**DOCKETED**  
**12-AFC-03**

# **AES Redondo Application Data Adequacy Assessment**

**Submitted on Behalf of the Residents of Redondo Beach and Hermosa Beach**

# AES Redondo Data Adequacy Assessment

**Figure 1: The AES site is closely surrounded on all sides by incompatible uses. This is no place for a power plant.**

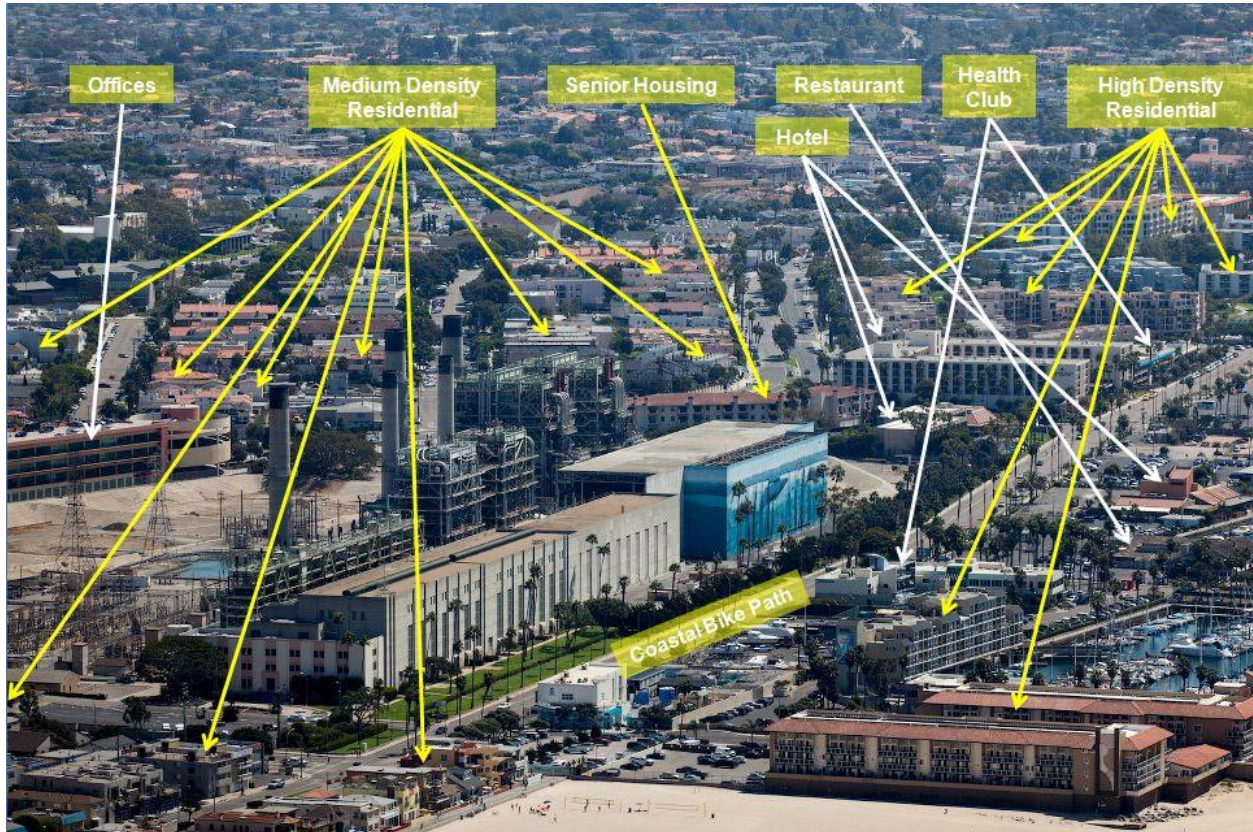
While AES discusses the surrounding land uses, it does not adequately reflect the extent of the situation. The AES plant is incompatible and tightly surrounded on all sides by other uses as shown in Figure 1.

To the north is high density residential development in Hermosa Beach. Hermosa's population density is over 13,000 people per square mile making it one of the most densely populated Cities on the California Coast.

Immediately to the east, the AES property is abutted by the Redondo Tech Center office building and a commercial site that has been approved for a new commercial project. Across the street are medium density residential neighborhoods of Redondo Beach. Redondo's population density is just under 11,000 people per square mile.

Immediately to the south is the Salvation Army senior housing center and a hotel. Beyond that is another hotel and gym and the highest density residential development in Redondo Beach.

To the west are two high density residential developments, boat liveaboards in King Harbor, restaurants, gyms, the coastal bike path, Seaside Lagoon (a unique saltwater recreational facility), a newly approved hotel development and four marinas.

Clearly, the site is inappropriate for large industrial development. Industrial uses are incompatible with the surrounding uses and the extremely tight proximity of these land uses renders the impacts beyond mitigation.

**Figure 2: Oblique view of AES site shows how any 85 foot facility would dominate the surrounding uses.**

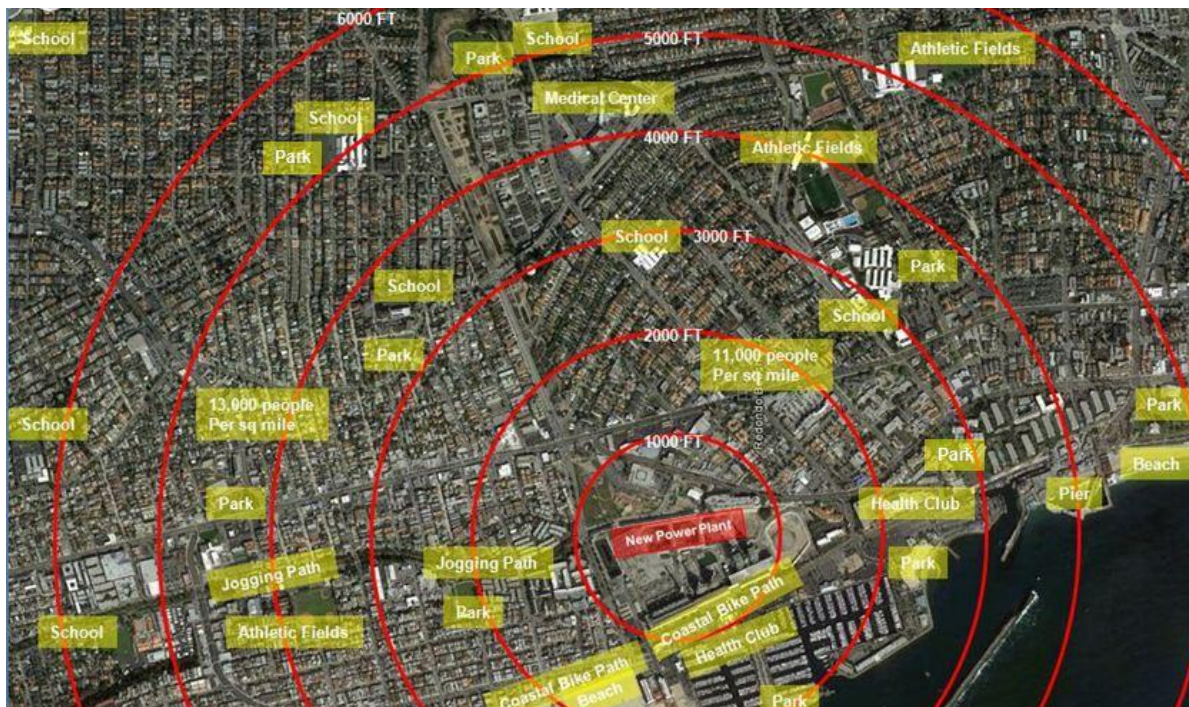
Figure 2 gives a better perspective of the site and its close proximity to incompatible uses. There is no denying that an 85 foot high power plant anywhere on this site will have a dominant and unavoidable negative impact on all the surrounding uses. While AES tells the public the plant will be hidden from most views, the site and proximity make this impossible.
